Aspen Business Park

Response to Pre-Application/ Other
Review Comments

Wednesday, May 04, 2022

Re: Aspen Business Park Master Plan
Application Number: DA-2304-00
Case Number: 2022-7001-00

PIP-1

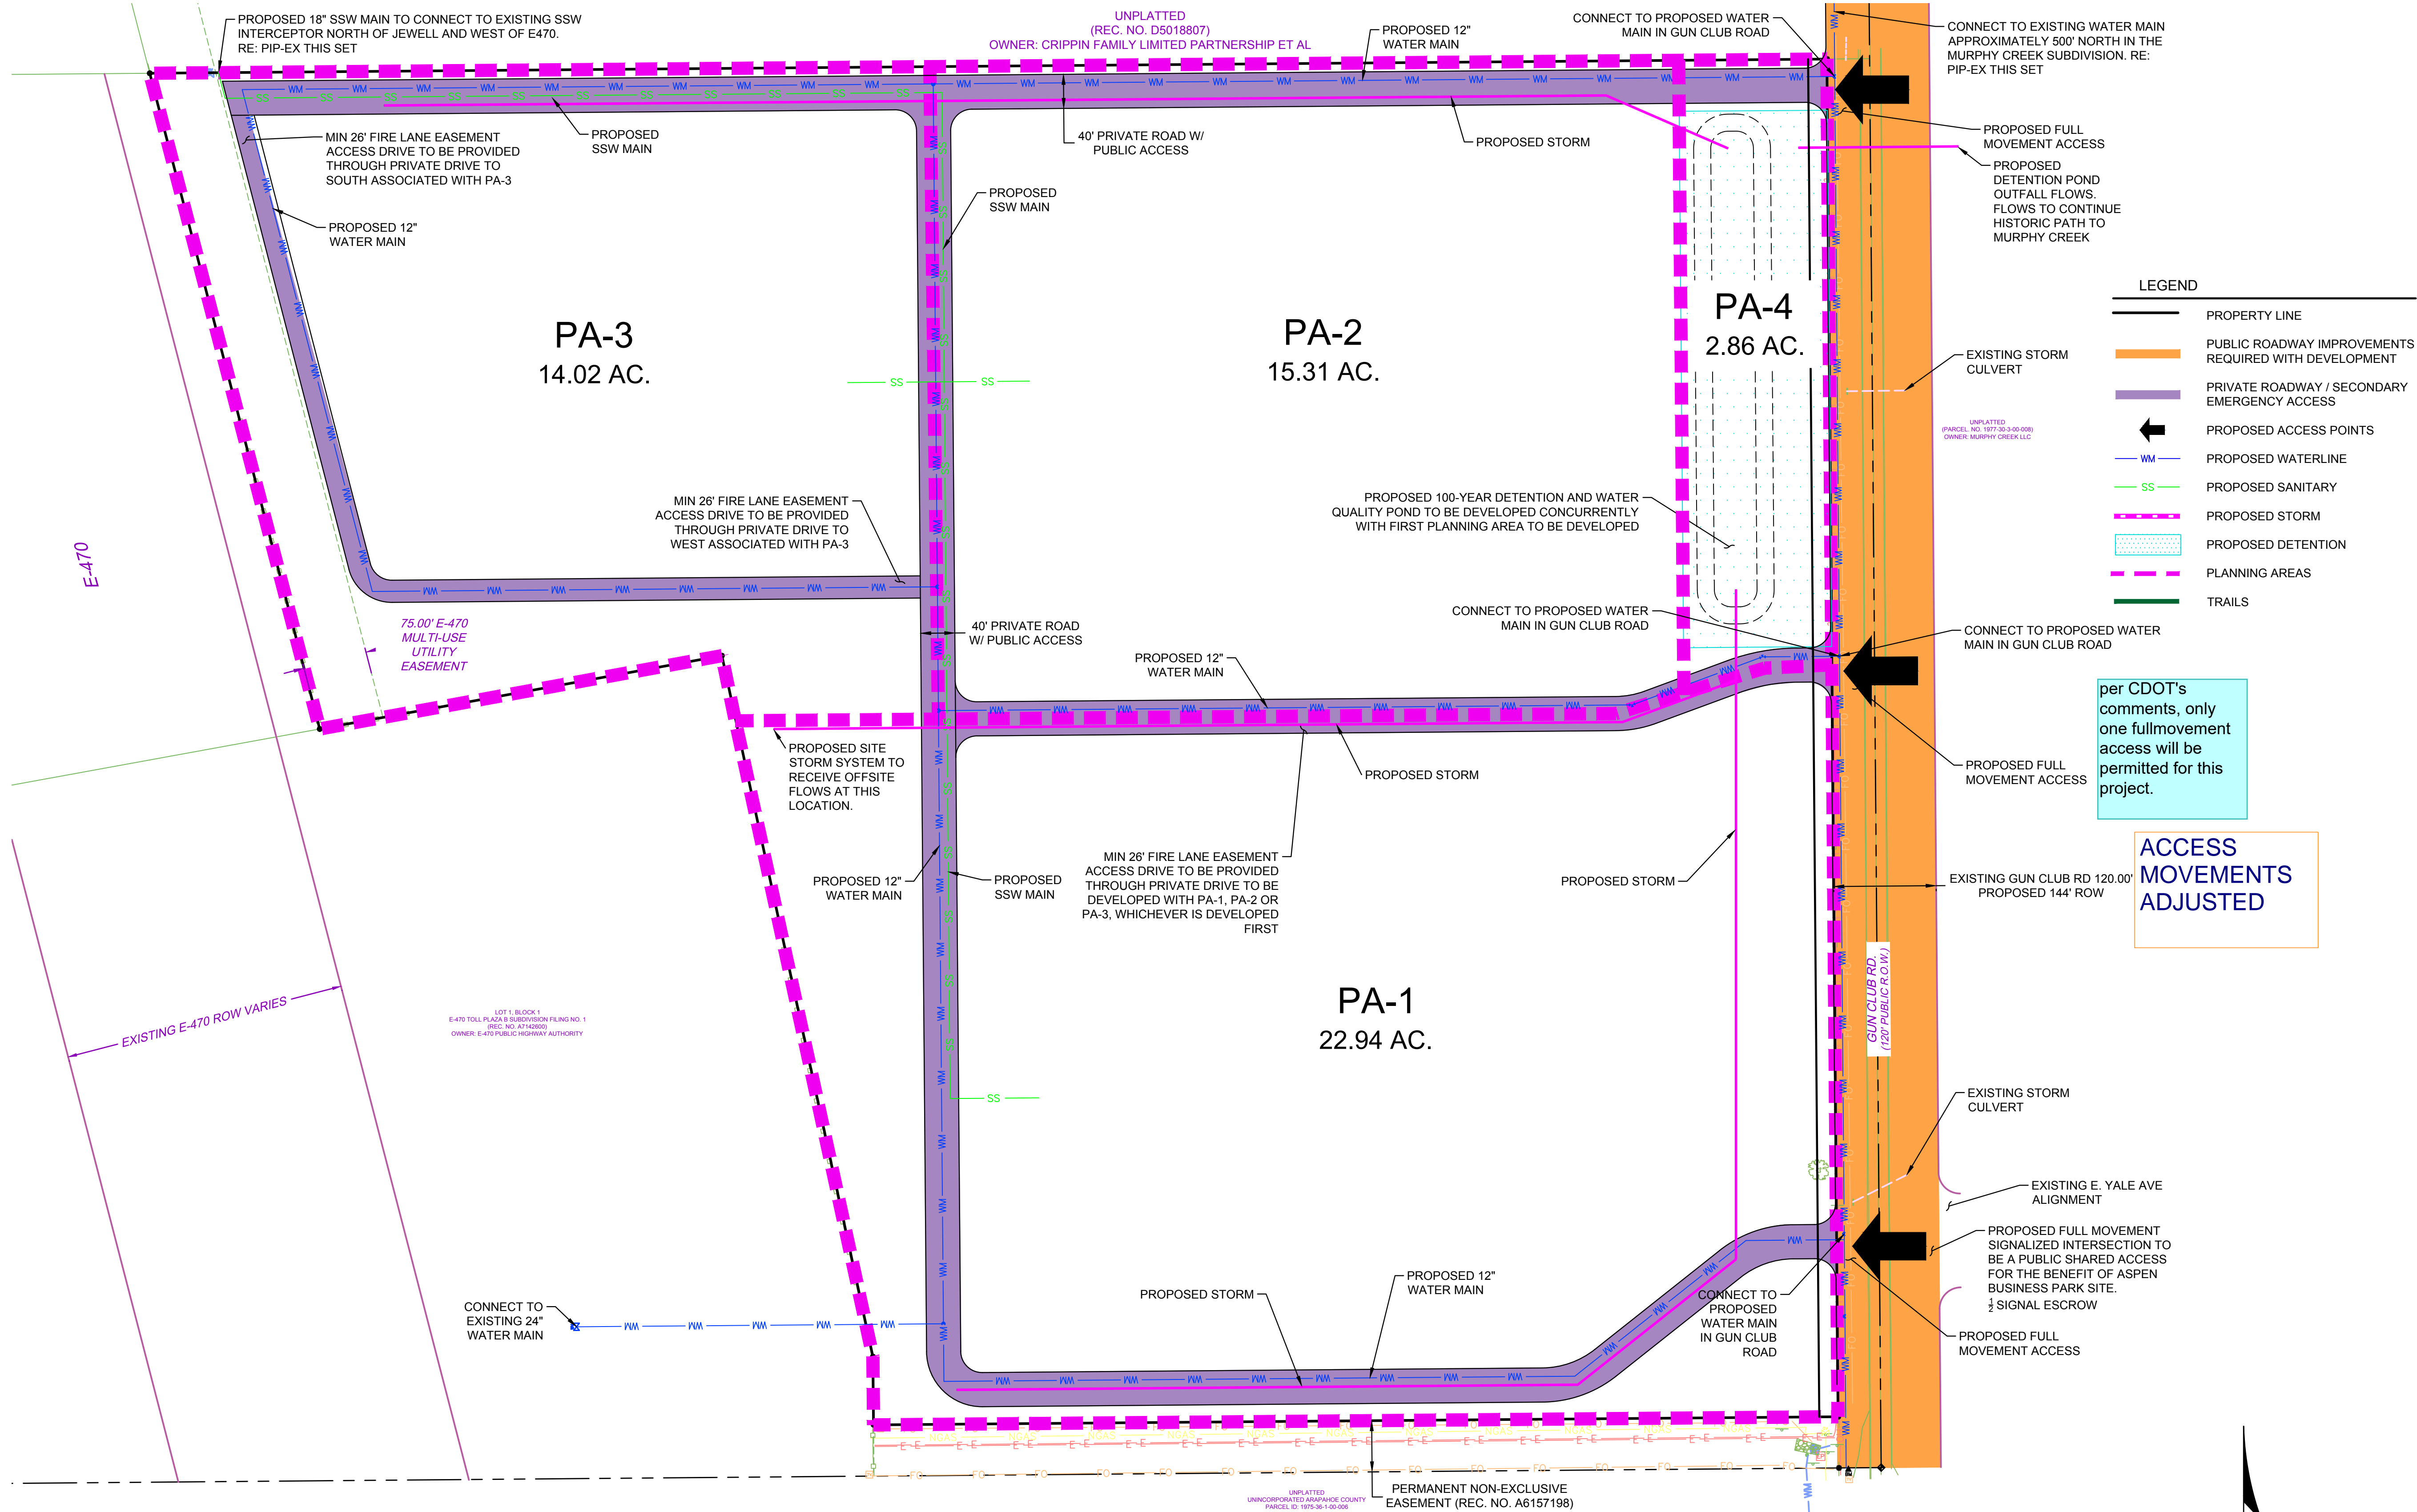
Ensure the 2% you are dedicating toward open space is noted to meet the 24-hour recovery period after any storm event. See the PROS manual for further information on this type of dedication

Trail would need to be provided, cannot just be a few benches or tables, would need to provided access to those amenities.

THE 2% OPEN SPACE AREA IS PROVIDED OUTSIDE THE DETENTION. TRAIL LANGUAGE ADDED TO TEXT FOR CLARITY

PIP-2

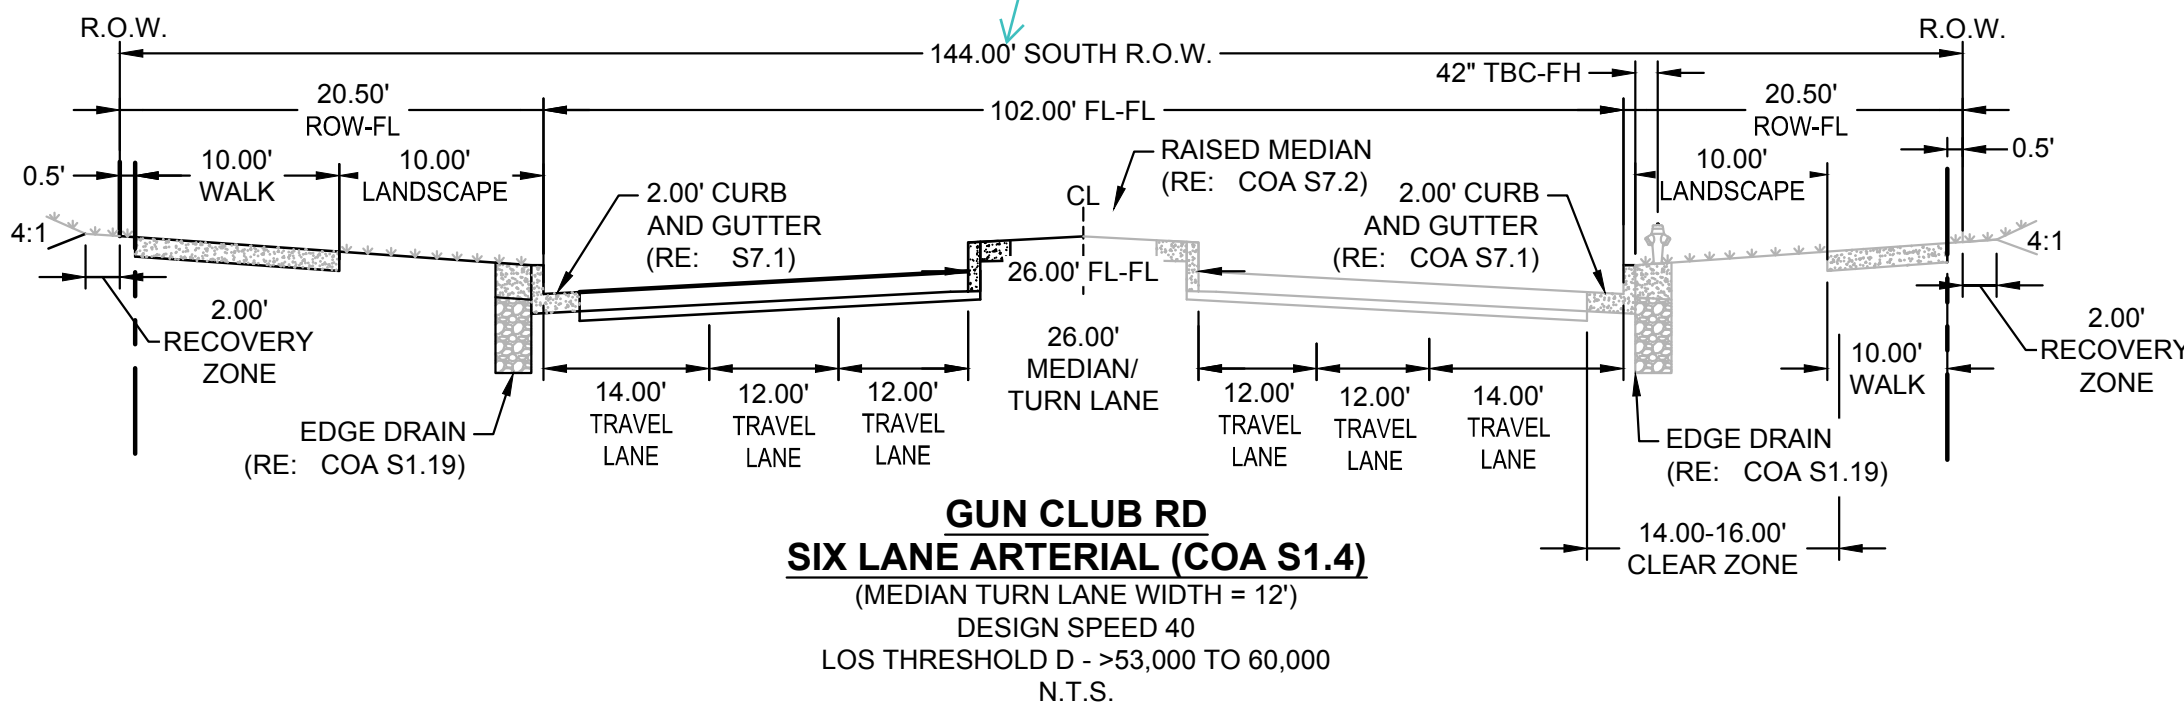
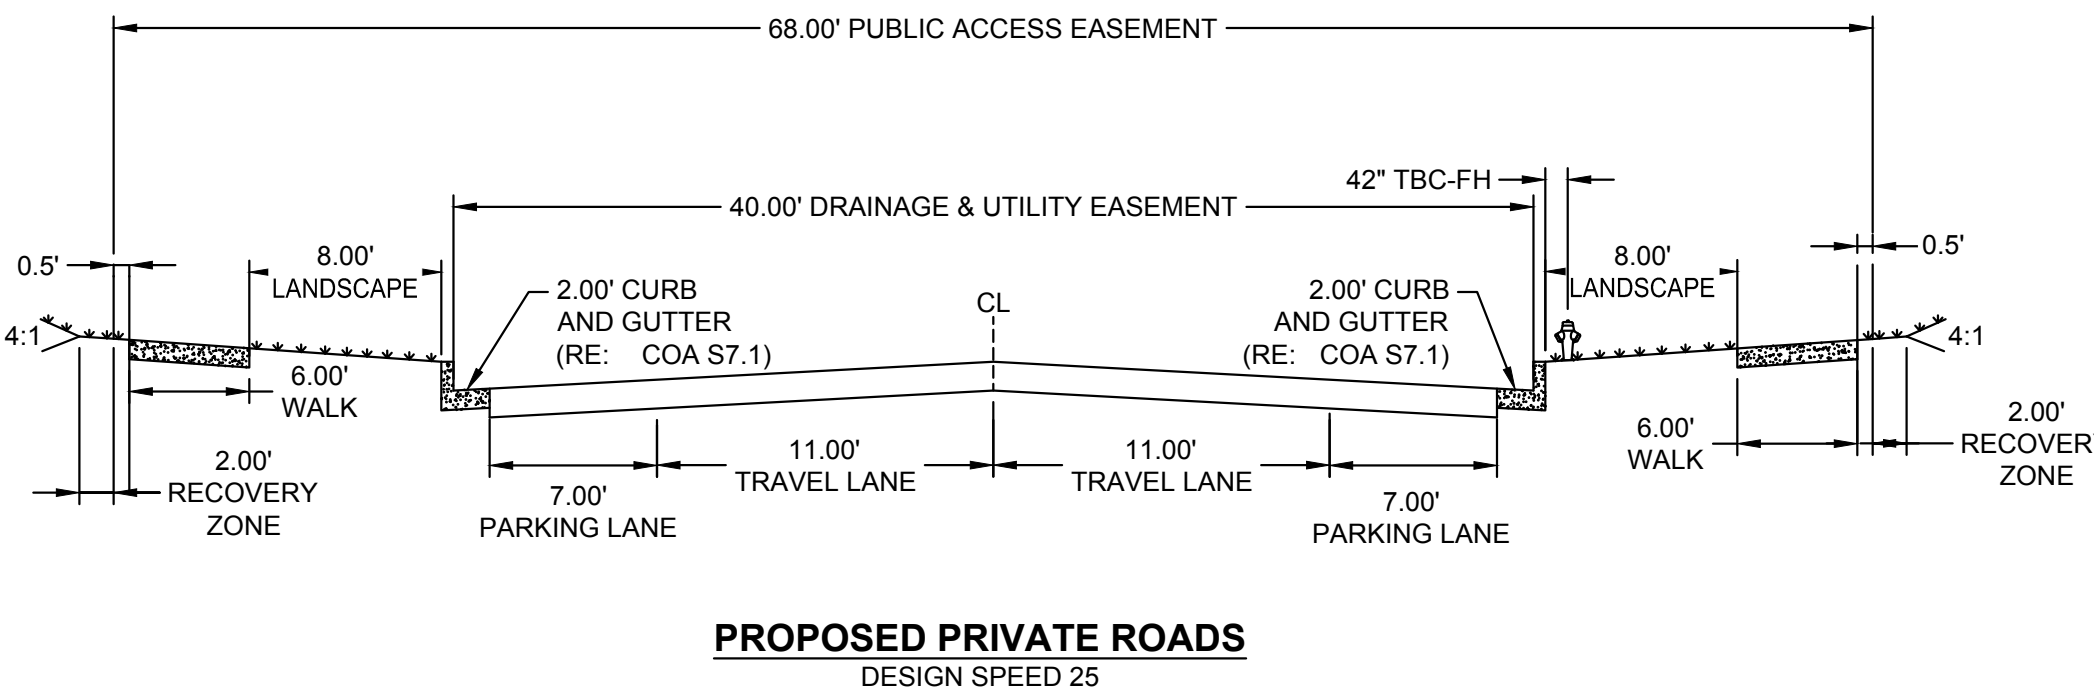
study was not included with this submittal

remove decimals. TYP

With the private roads, are fire lanes not included?

TIS WAS TO REVIEWER AND PLANNING SUBMITTED AND COMMENT STILL HAVE NOT BEEN RECIEVED TO THE POINT (5/4/22)

DECIMALS HAVE BEEN REMOVED

FIRELANE ADDED TO EASEMENT ROADWAY DIMENSION

ADT THRESHOLDS PER OCTOBER 2018 NEATS REFRESH

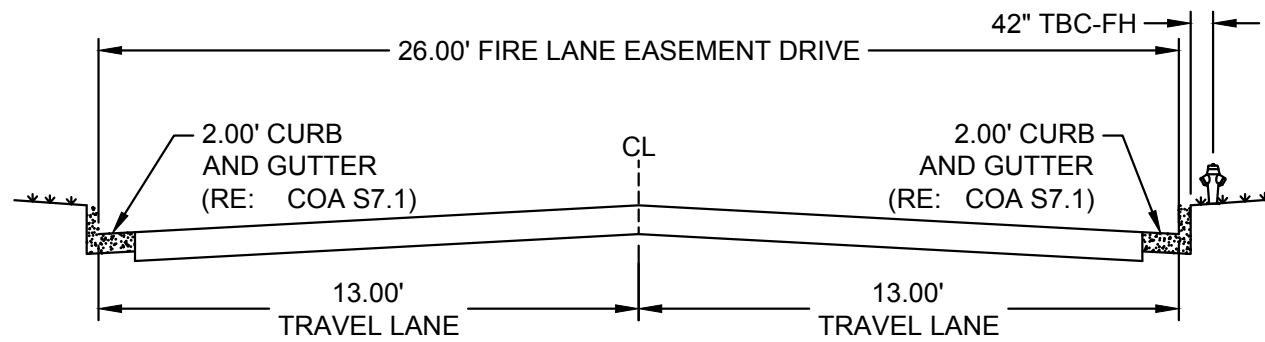
Is this for shared internal streets or individual sites? easements that will be required for individual sites will be addressed during Site Plan reviews.

UNDERSTOOD

SHEET
C1
Sheet

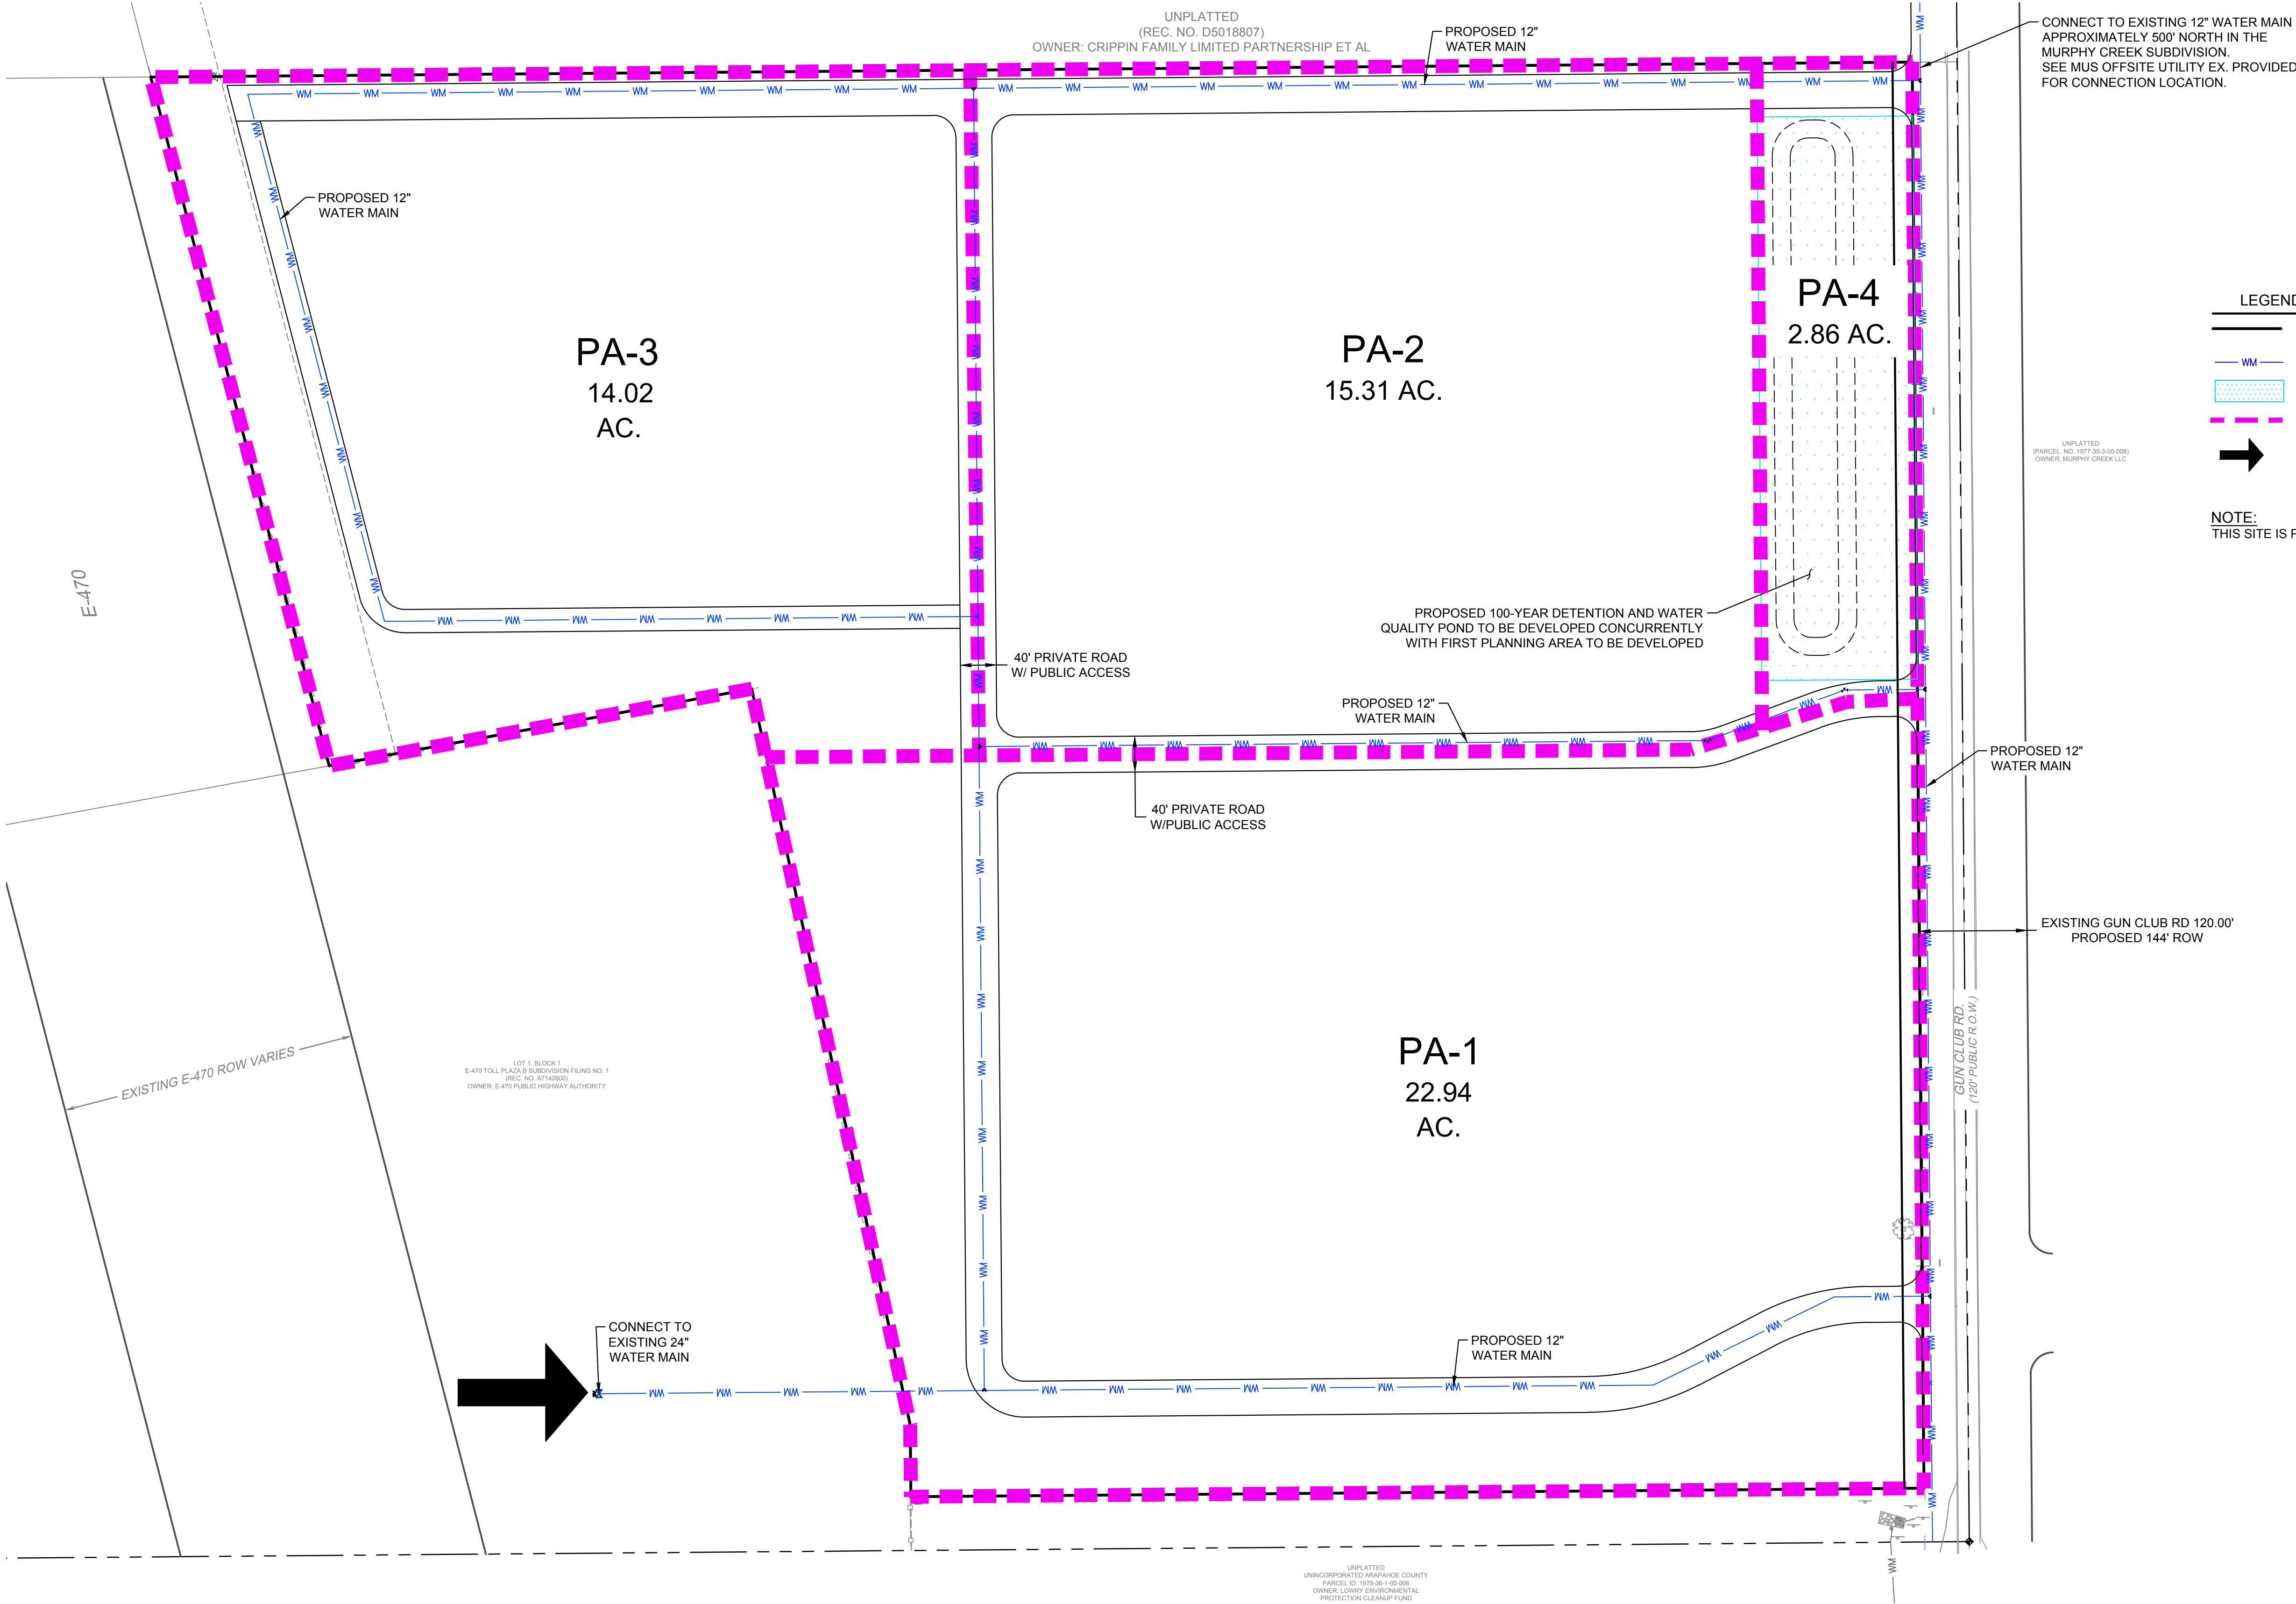
As previously stated, include signature block on water and sanitary exhibits. Including those in this report.

I asked you to attain a MUS checklist from me- as it is not available online. Please email me so I can send it

SIG BLOCK ADDED.
THIS WAS NOT ADDED BECAUSE
IT WAS REQUESTED FOR
SIGNATURE SET. TO MY
KNOWLEDGE SIGNATURE SET
WAS NOT REQUESTED.
